## Executive Director's Recommendation

Commission Meeting: July 11, 2019

<b>PROJECT</b> <b>Exterior Lighting and Revised Gate at Planet Word</b> 925 13th Street, NW Washington, DC	<b>NCPC FILE NUMBER</b> 7932
<b>SUBMITTED BY</b> District of Columbia Office of the Deputy Mayor for Planning and Economic Development	<b>NCPC MAP FILE NUMBER</b> 21.00(38.00)44963
<b>REVIEW AUTHORITY</b> District Projects in the Central Area per 40 U.S.C. § 8722(b)(1) and (e)	<b>APPLICANT'S REQUEST</b> Approval of revised final site and building plans
	<b>PROPOSED ACTION</b> Approve revised final site and building plans
	<b>ACTION ITEM TYPE</b> Staff Presentation

# Exterior Lighting and Revised Gate at Planet Word

# Proposed Lighting for West Façade of Franklin School

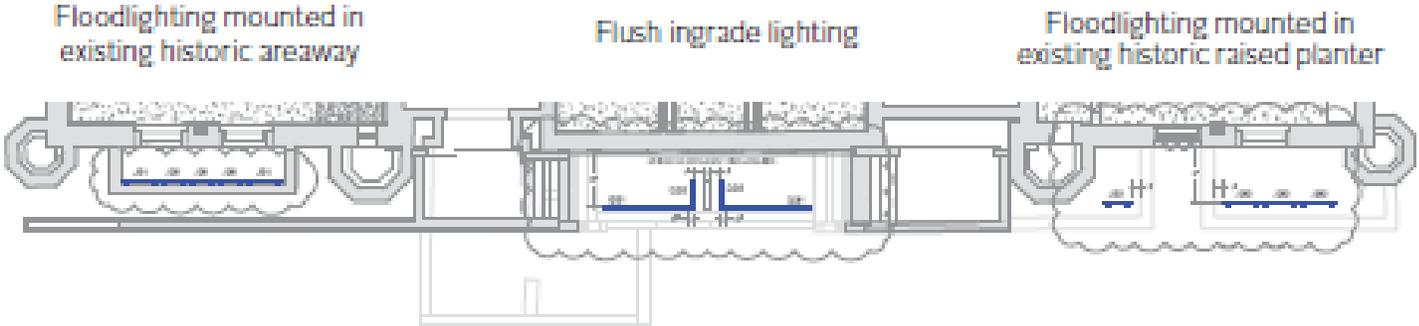
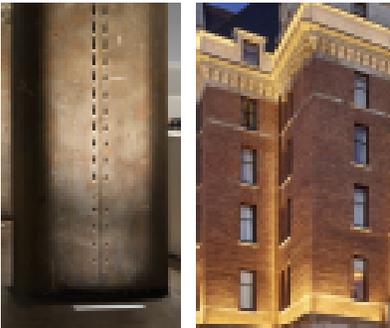
The exterior lighting proposed consists of flushed inground mounted lighting for the approved monument and banner signs, and flood lighting for the west façade of the Franklin School, mounted in the existing areaway, stair landing, and planters, all on the west elevation of the building. The approved signs and the proposed lighting for the signs and the west façade of the building are located outside of the building property line and in public space. Therefore, staff notes that any improvements in public space will require a public space permit and coordination with the District of Columbia Department of Transportation Office of Public Space.

Overall, staff believes the lighting approach is appropriate and sensitive to the design of the building. It is minimal in its approach by only providing focused lighting to the three signs and to the main façade of the building, facing Franklin Park.

# Previous Proposed K Street Entry Gate

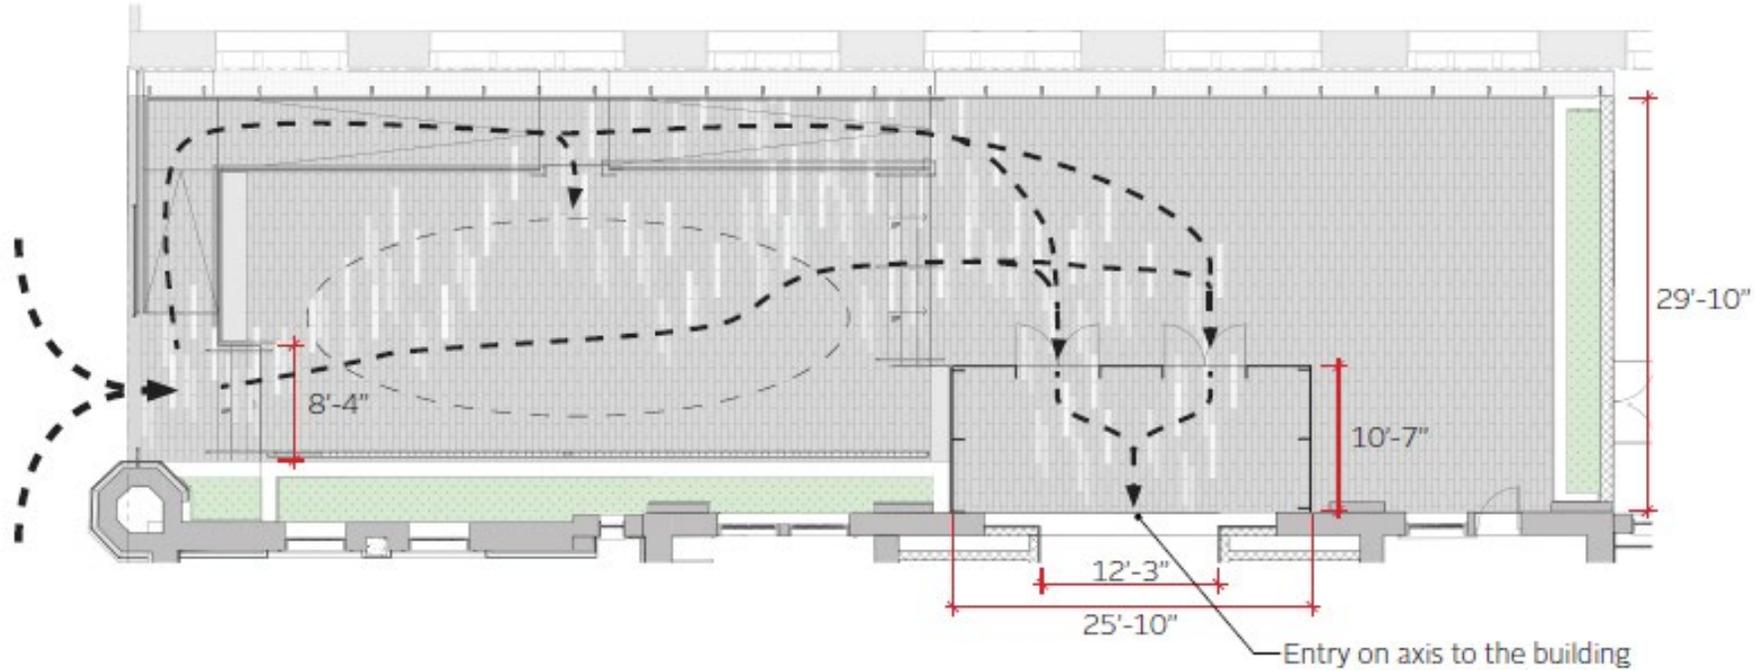
The previous entry gate design was intended to resemble a book opening and closing. The Commission had previously commented on the heaviness of that design, and questioned whether the low point in the gate “fan” would allow someone to easily climb over, posing a security issue. Overall, the Commission supported relating the design of the gate to aspects of the museum mission.

Based on the Commission discussion at the March 7 meeting, the applicant has revised the gate design. The new design now relates to the vocabulary of the Speaking Willow sculpture located in

the new terrace and provides both security and transparency to appreciate the sculpture and space when Planet Word is not open. The abstracted organic tree pattern borrows on the regular rhythm of the existing railings in the school without being a literal re-interpretation. The panels are of the same aluminum powder coated water jet cut material and color as the previously approved gate. Thus, staff notes that the revised entry gate off K Street includes a design that relates to the Speaking Willow Sculpture in the new entrance terrace.

# K Street Gate, Showing Proposed Revised, Sliding Panels

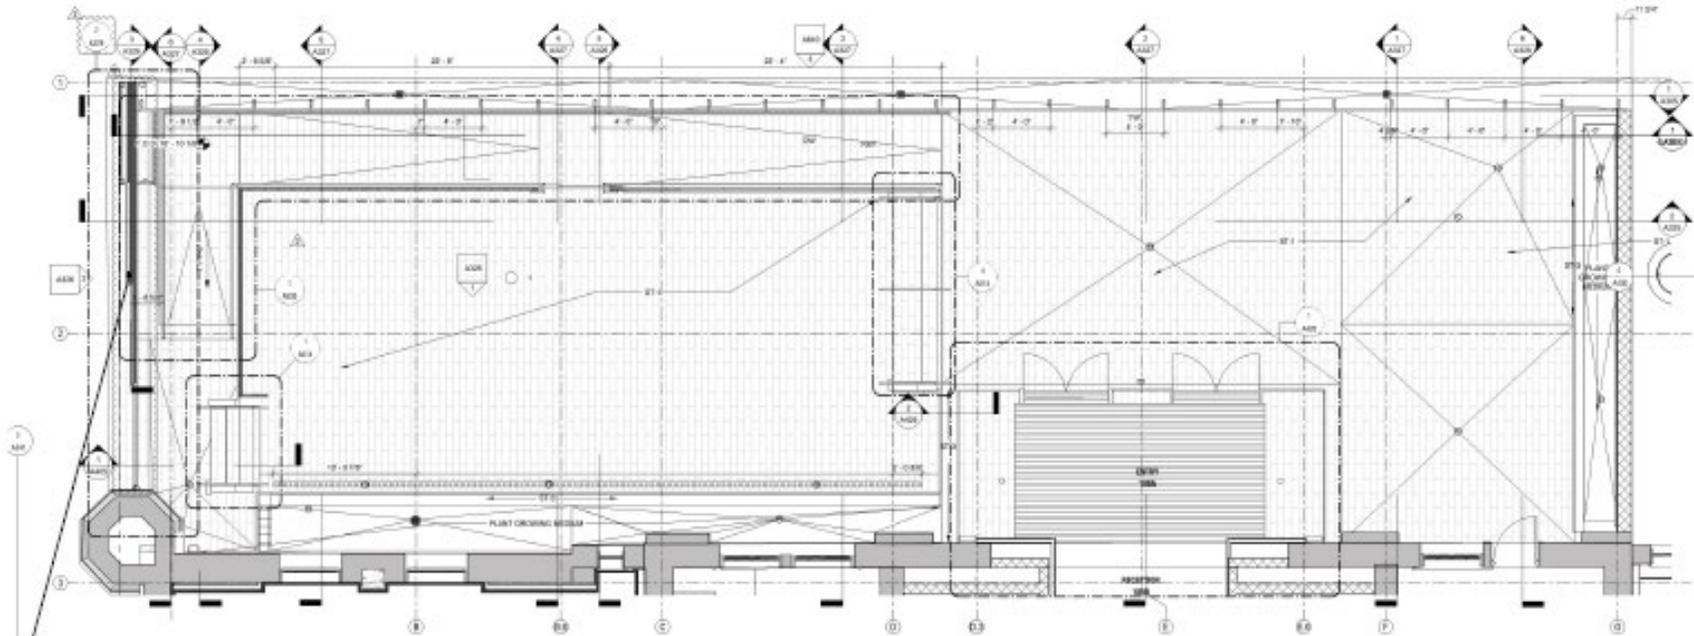
The gate is comprised of three sliding panels that retract behind a fourth fixed panel when opened. No component of the gate is directly attached to the historic building. It is also not connected to the building at the east end of the site. The sliding panels open away from the entry stair and ramp landing when in the open position. When retracted, the panels screen the mid landing of the ramp while retaining an open sense for the terrace. The Speaking Willow is visible and framed both while the gate is open. When the gate is closed, passers-by can see still the Speaking Willow and the rest of the courtyard, avoiding the feeling of a gated community.

Proposed Gate  
Panels slide west away from  
entry when opened.  
The gate remains unconnected  
to the historic building.
